ADDENDUM TO INVITATION FOR BIDS
Fortuna Elementary School District
Proposition 39
South Fortuna Elementary School Furnace Replacement
Bid No. 17-007

Addendum #1
March 23, 2017

South Fortuna Elementary School Site Map

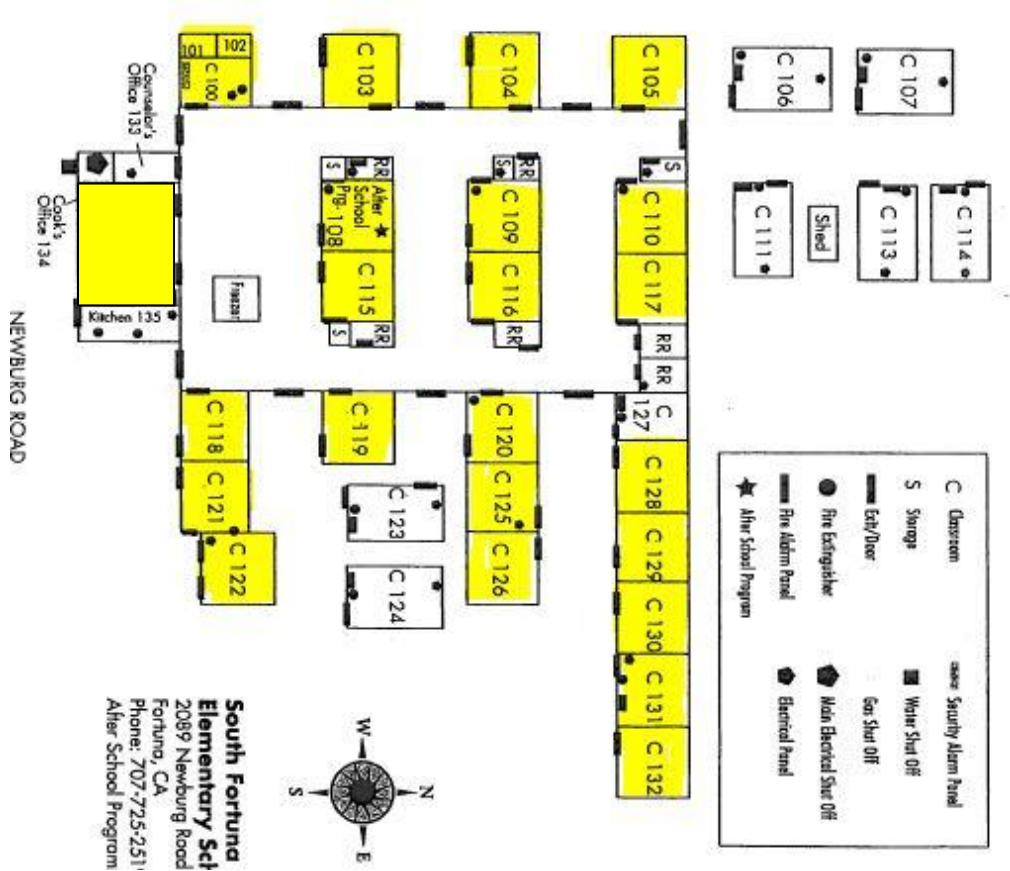
- Title changed from Appendices to Appendix A
 - Existing furnaces table updated and expanded.
 - South Fortuna Elementary School Site Map is updated with highlighted Cafeteria.
5. This addendum and an amended version of the complete Invitation for bids are available on our website at www.redwoodenergy.org.

Highlighted areas are included in the Scope of Work.
